AGENDA
CITY OF CREVE COEUR
PLANNING AND ZONING
300 NORTH NEW BALLAS RD
MAY 1, 2023
6:00 PM

1. Application #23-011: Minor Site Plan for a Fence Within the Front-Yard Setback Along Mosley Forest Drive for the Property Addressed as 9 Ladue Meadows

2. Application #23-012: Site Development Plan For Parking Lot Addition at 633 Emerson Road

3. Application #23-008: Application for a Site Concept Plan for the Creve Coeur Plaza Mixed-Use Development at the Southeast Corner of Olive Boulevard and North New Ballas Road

Figure 1: Applicant's Site Plan with fence location in red.

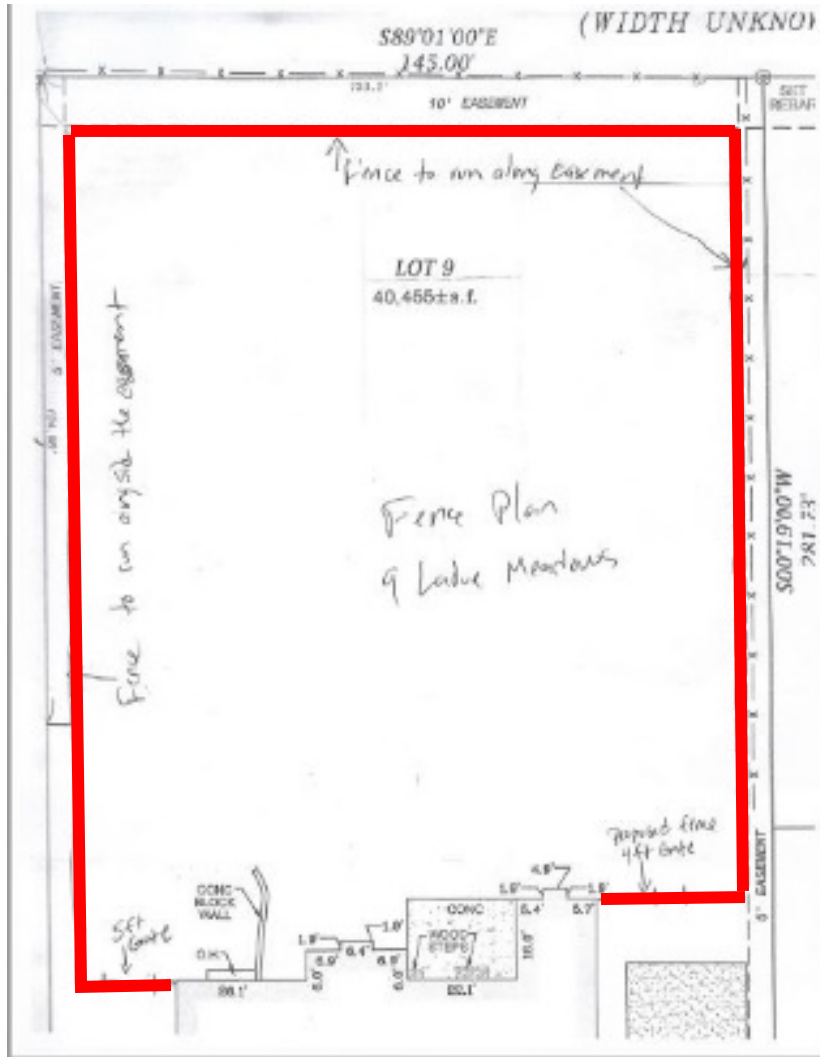
The Applicant is seeking to install a 4.5 foot (54") tall black aluminum fence, approximately 10 feet from the rear property line, within the area equivalent to the front-yard setback along Mosley Forest Dr. The fence would be just inside of the existing dense shrubs and not generally visible to those on Mosley Forest Drive. The applicant chose the material in order to match the fencing material of their neighbor at 11 Ladue Meadows who received approval for a similar request in 2021.

If the members of the Planning Commission find the applicant’s reasons for the fence location, height, and design sufficient, they can approve it as proposed. If the Commission wishes to revise the location, material or height of the fence, discussion with the Applicant and a revised motion would be necessary. If the request is denied, the Applicant may construction the fence at the 50-foot setback line.

Figure 9: Close-up of the Landscape plan for the new addition and the billboard with highlighted areas of additional landscaping.

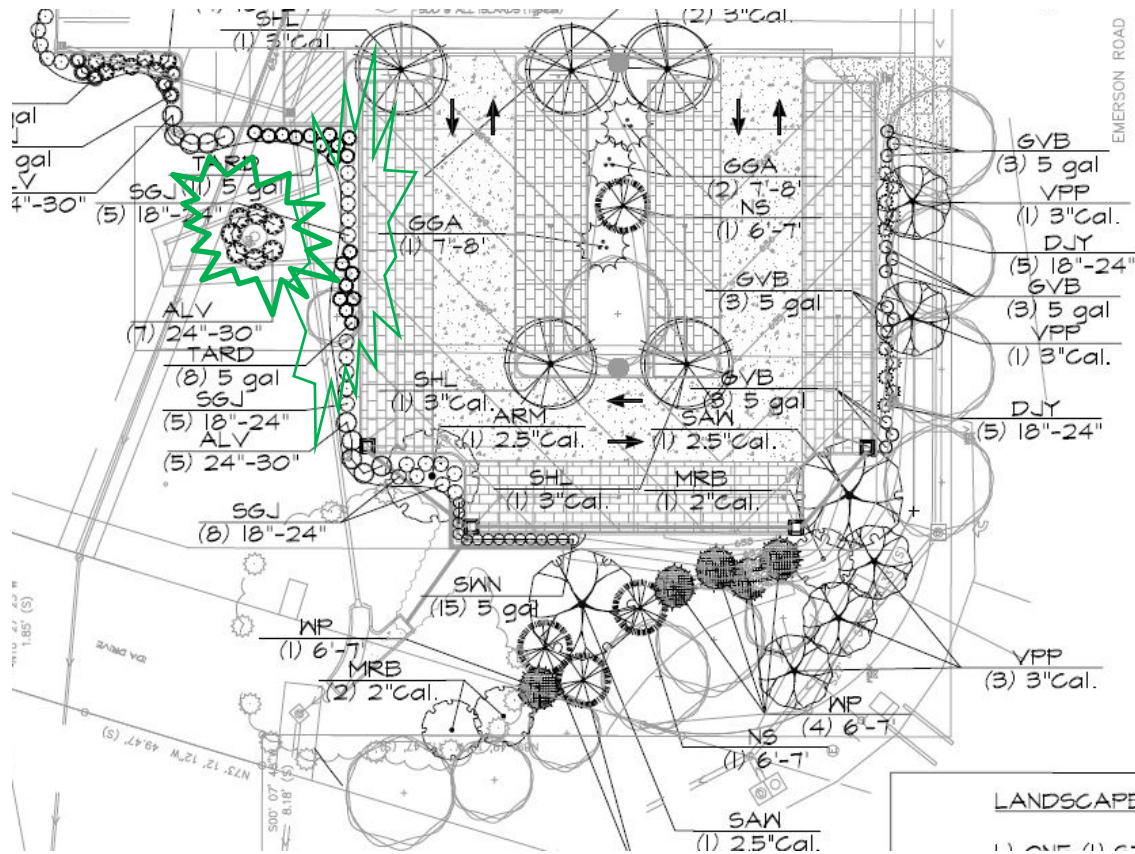
In the staff report from 2020, staff indicated that additional landscaping around the base of the billboard and around the perimeter of the new and existing parking lot to shield headlight glare was needed. The applicant's current landscaping proposal includes additional landscaping around the base of the billboard to include 7 viburnum shrubs and a mix of shrubs, including evergreens, along the parking area. Staff is satisfied with this modification. The existing site requires 18 street trees. 12 street trees exist and 6 are proposed to comply with the requirements mentioned above in Section 405.540 although not all are listed as 3 caliper inches at time of planting. This will be addressed with a condition of approval as will the

The subject property has a non-conforming billboard. Section 405.950(L)(2)(a) of the sign regulations states that all lighting and landscaping of grandfathered billboards shall maintain the previously approved and required landscaping. Staff does have a concern with the removal of the large evergreens that were required to provide screening for the residents to the south and east of the property and the parking so close to the billboard area.

The new parking area will be very close around the non-conforming billboard, and the new plantings will require time to provide the same screening as the existing on the site. The Applicants have indicated that they feel that additional parking is needed to ensure retention of tenants. They have added additional plantings to the south for screening purposes, and maintaining the existing trees that would be within the parking lot islands. If approved, the final landscape plan for this site will also serve as the required landscaping to satisfy the requirements of the billboard ordinance.

3. The Landscape plan shall be revised to include the plantings around the building as consistent with the approved plans in 2013; identify and replace all dead and dying trees and plants in order to provide attractive year-round screening along Emerson Road frontages, and any plant materials listed as an undesirable species, shall be replaced with a Missouri Native tree as recommended by the City's Landscaping Guide and Public Works Department's list of Recommended Trees, for the Zoning Administrator's approval.

Figure 10: Close-up of the Applicant's Photometric Plan showing that lighting levels to be less than 1 fc at the property line.

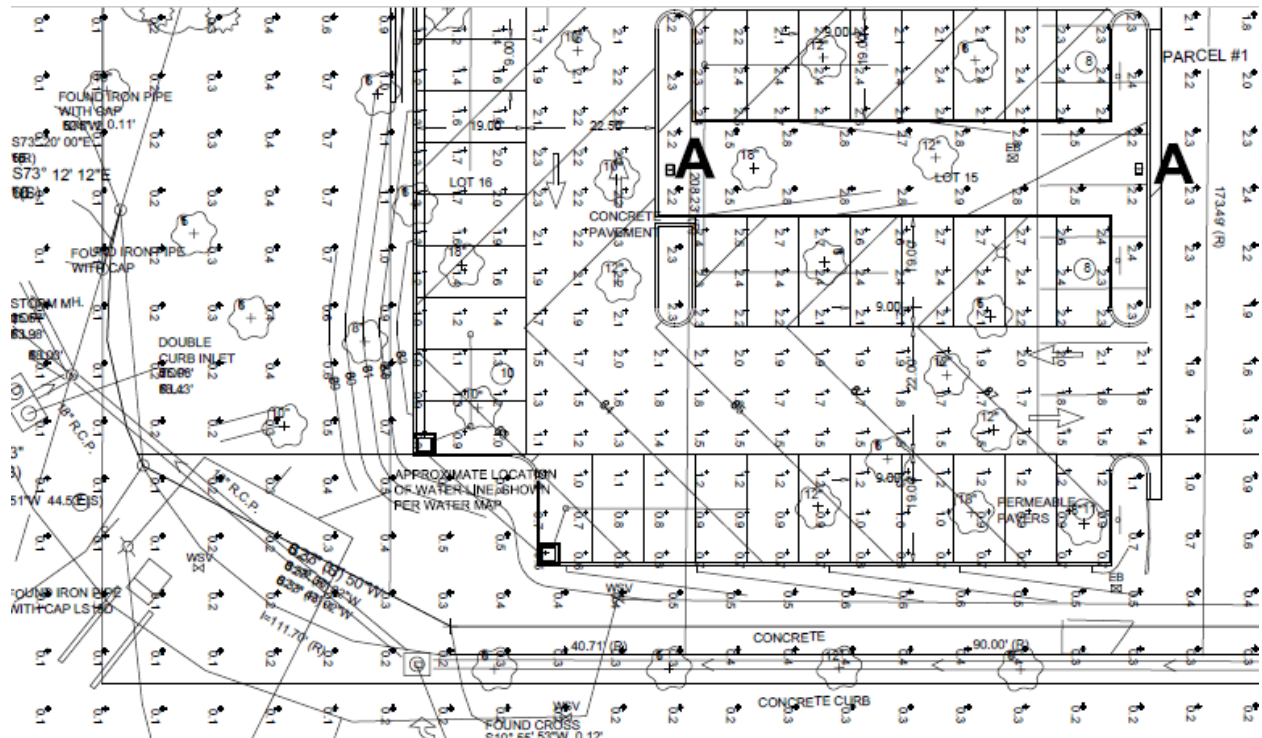
The new parking area is proposed for new lighting that meets with these regulations. However, the site photometric plan indicates that the existing parking lots are flood lights. Therefore, a condition of approval includes that all lighting shall be downcast and fully shielded, and that the existing flood lights shall be replaced with the same light fixtures as the proposed new fixtures. If additional light fixtures are needed, Staff has included a condition that Staff shall have the authority to approve additional light fixtures to meet with the requirements above.
